### Town of Thompson's Station Municipal Planning Commission Meeting Agenda June 28, 2016

### Thompson's Station Planning Commission Staff Report – Item 1 (PP 2016-004) June 28, 2016

### Thompson's Station Planning Commission Staff Report – Item 2 (File: SP 2016-003) June 28, 2016

### Thompson's Station Planning Commission Staff Report - Item 3 (File: FP 2016-002) June 28, 2016

LAYOUT, GRADING & UTILITIES PLAN

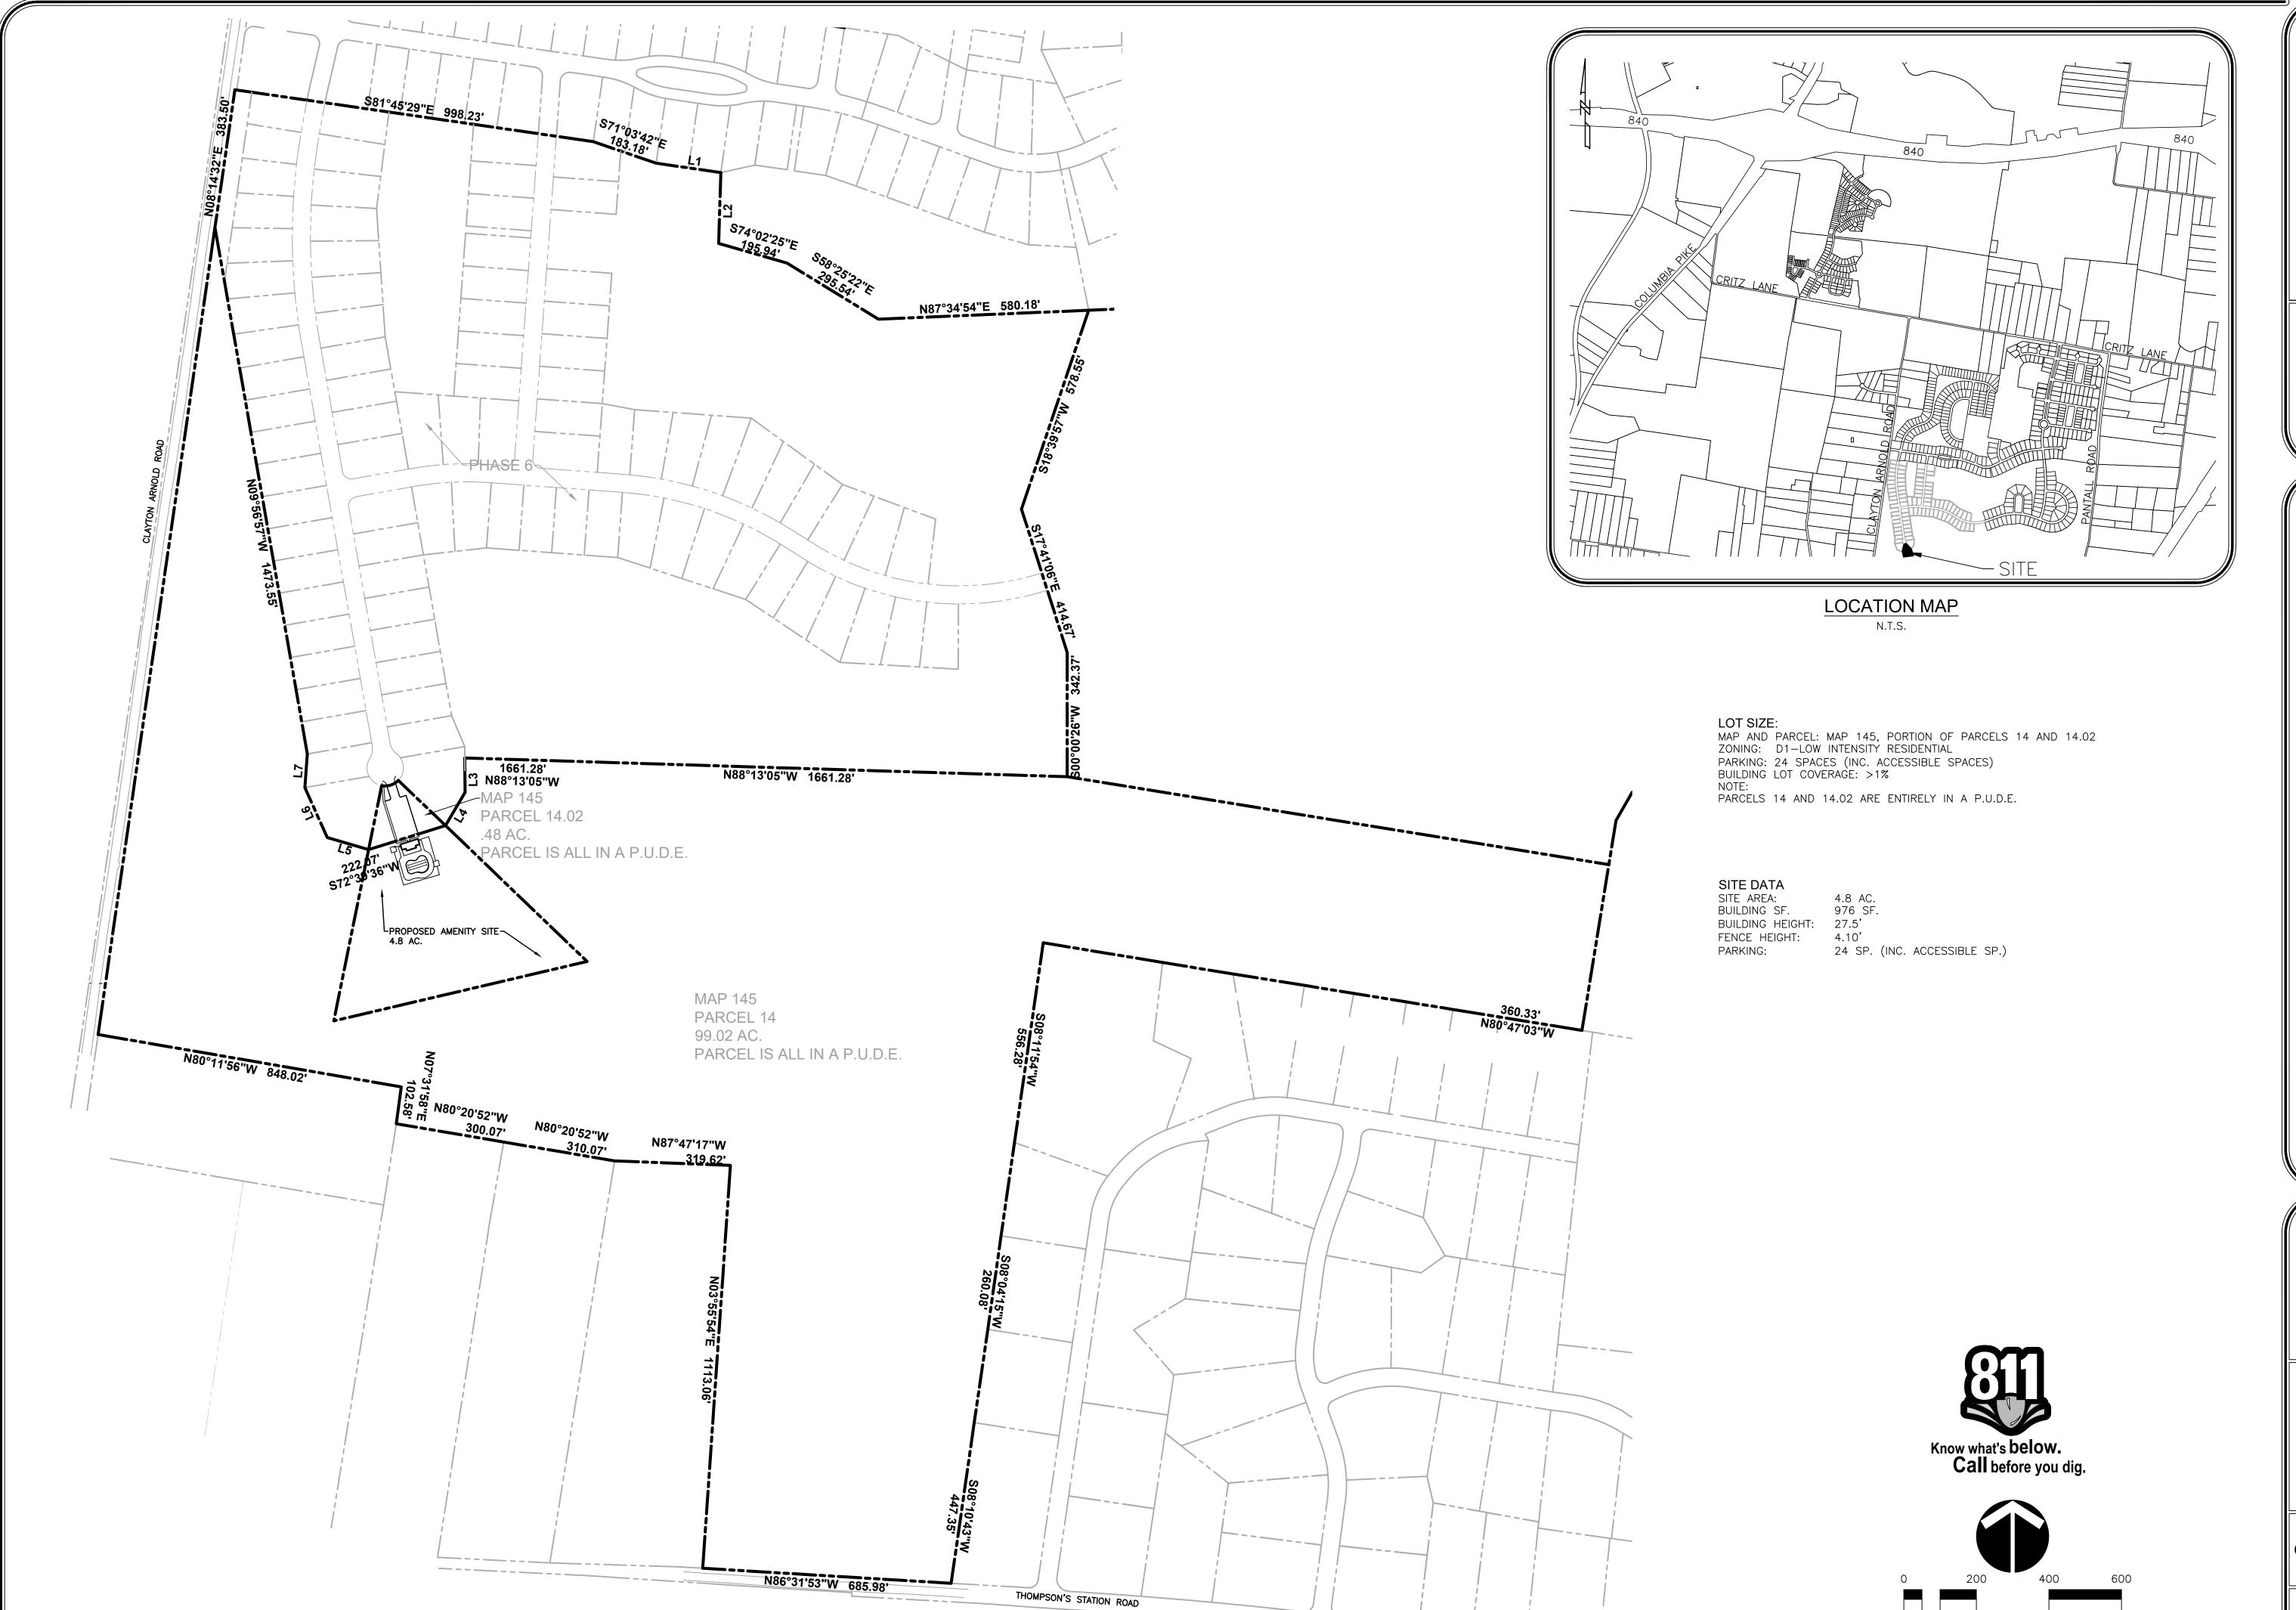
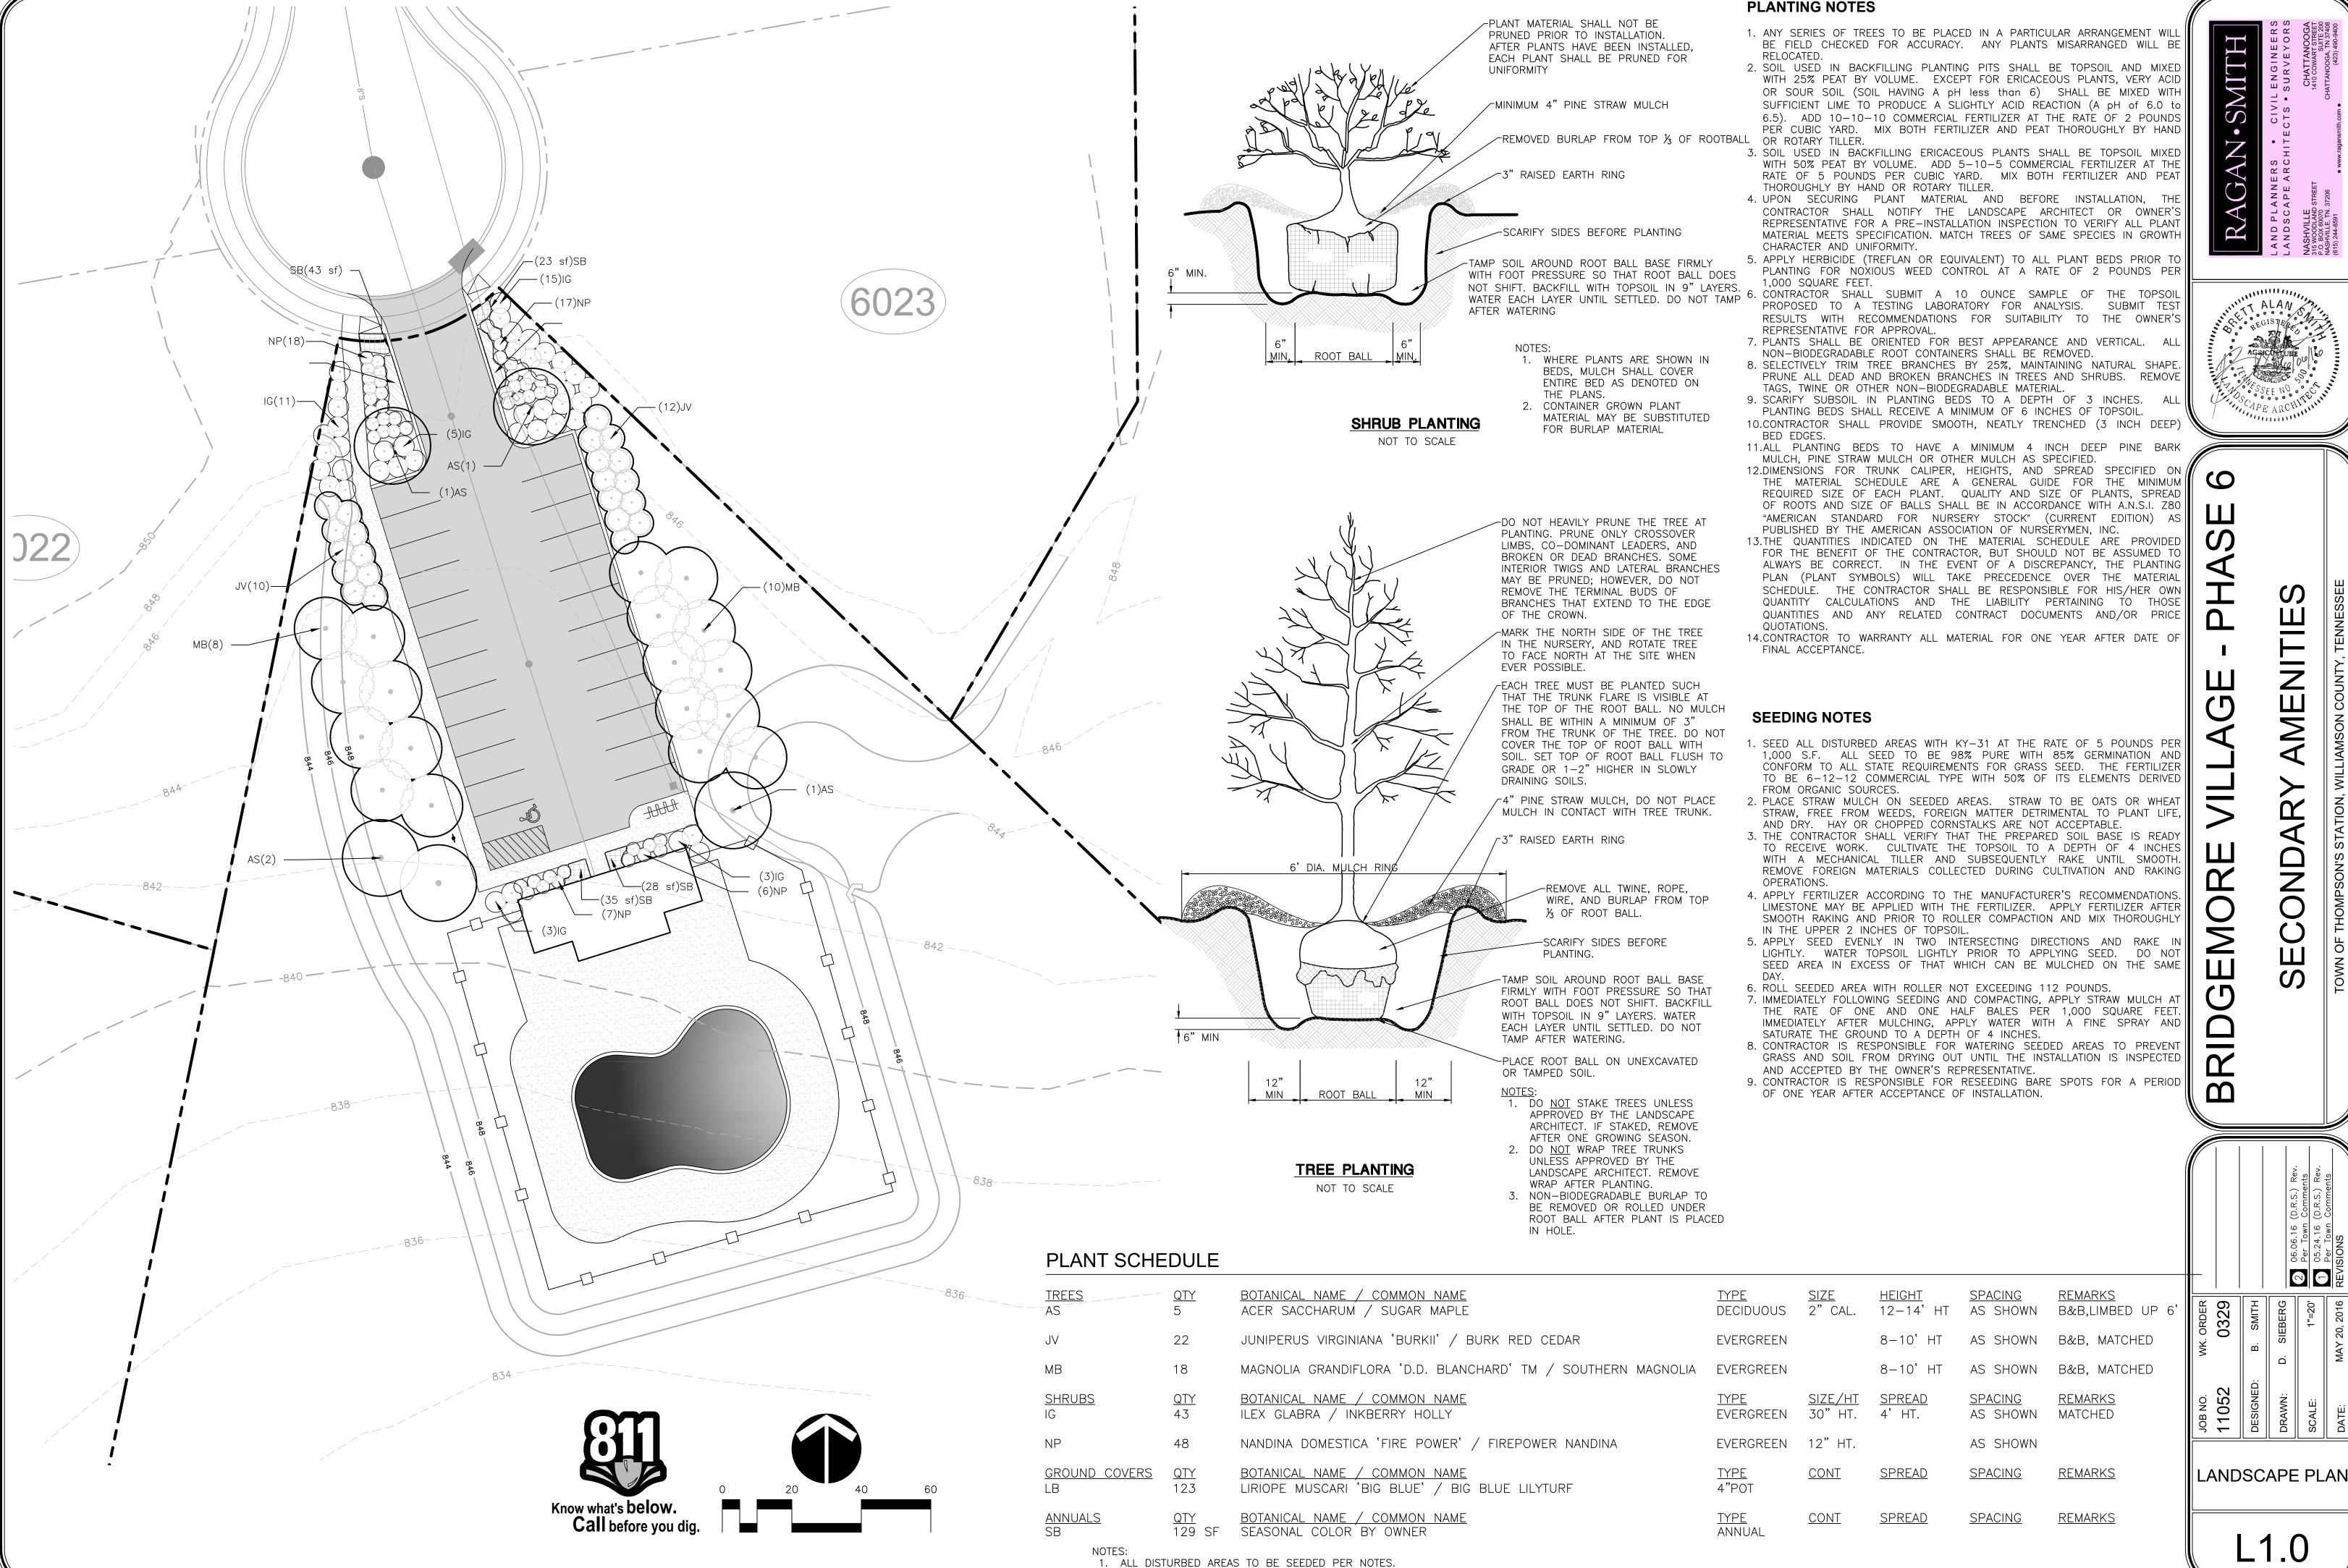
The project site is located at the end of a cul-de-sac with residential lots adjacent to the amenity center. The Land Development Ordinance requires that a buffer be installed that includes a semi opaque screen (buffer type 2). The proposed landscaping includes magnolia trees and cypress trees along the edges of the parking lot. However, Staff recommends the addition of similar evergreen trees around the southwest property line of Lot 6023 and the southeast property line of Lot 6022 to provide adequate buffering. Therefore, Staff recommends a contingency to incorporate additional landscaping along these property lines.

1. Prior to issuance of grading or building permits, construction plans shall be submitted and approved.

- 2. Prior to the issuance of a building permit, the lot for the amenity center shall be approved and recorded.
- 3. Prior to issuance of grading or building permits, the landscape plan shall be revised to incorporate a buffer along the property lines of the adjacent lots.
- 4. Prior to installation of the landscaping, the applicant shall meet with staff to confirm location of all landscaping.
